**UPPER SKAGIT INDIAN TRIBE
STEP #2 RECIRCULATION PROJECT**

**ADDENDUM NO. 1 (10 pages total)
Issue Date: February 8, 2018**

DETAIL A1 – ASPHALT RESTORATION

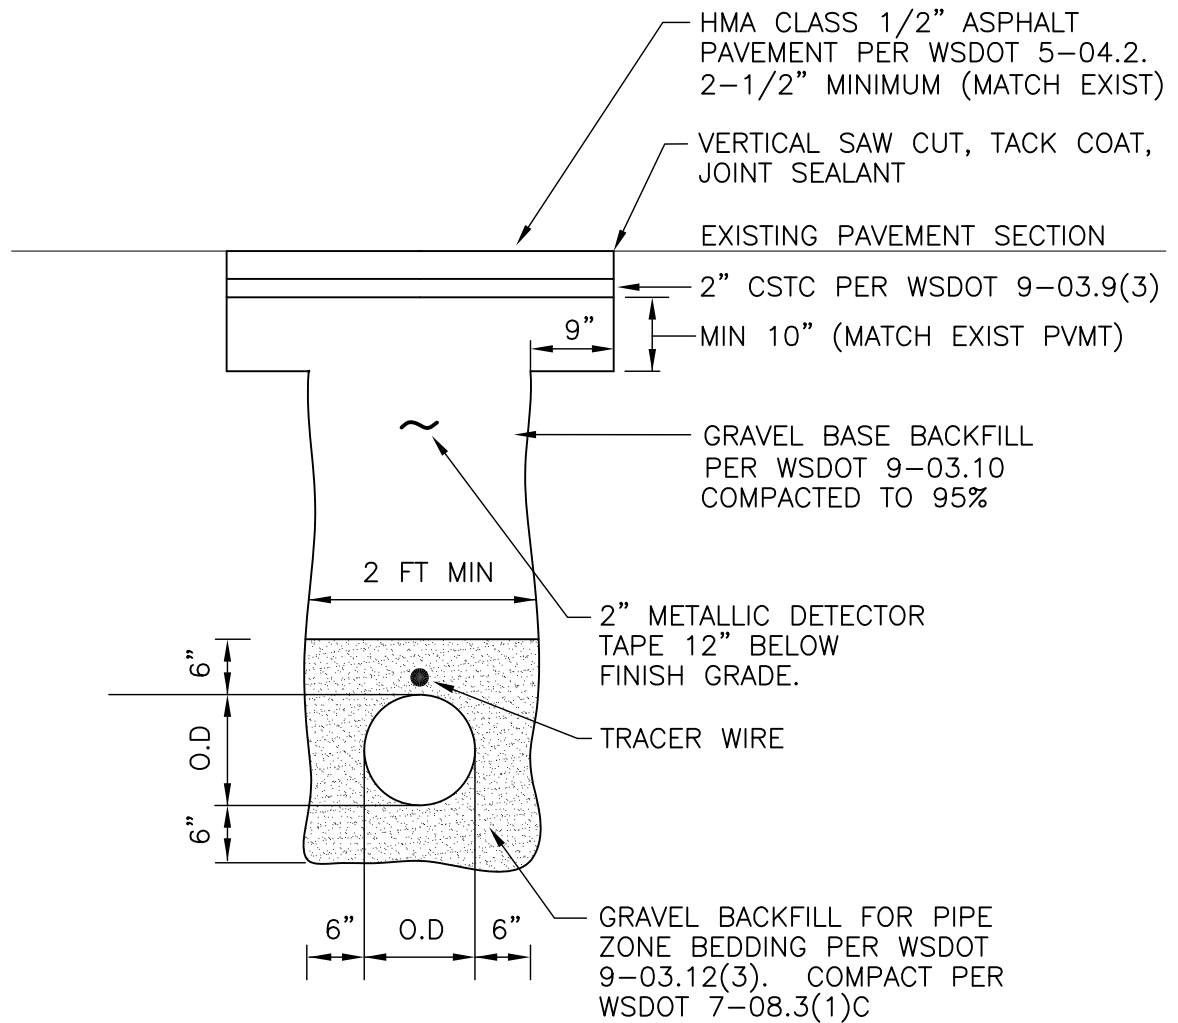
ADD Bid Item No. 23: Spec Section 4-02, "Gravel Base", 7 CY. This bid item is for repair of asphalt roadway. It is anticipated that the two tie-in to existing Treated Effluent pipe areas will require removal and replacement of asphalt roadway in the shoulder of the road. Asphalt repair areas will be performed per detail A1 in this addendum.

ADD Bid Item No. 24: Spec Section 4-04, "Crushed Surfacing Top Course", 0.4 CY. This bid item is for repair of asphalt roadway. It is anticipated that the two tie-in to existing Treated Effluent pipe areas will require removal and replacement of asphalt roadway in the shoulder of the road. Asphalt repair areas will be performed per detail A1 in this addendum.

ADD Bid Item No. 25: Spec Section 5-04, "HMA Cl. 1/2" PG 64-22", 0.4 CY. This bid item is for repair of asphalt roadway. It is anticipated that the two tie-in to existing Treated Effluent pipe areas will require removal and replacement of asphalt roadway in the shoulder of the road. Asphalt repair areas will be performed per detail A1 in this addendum.
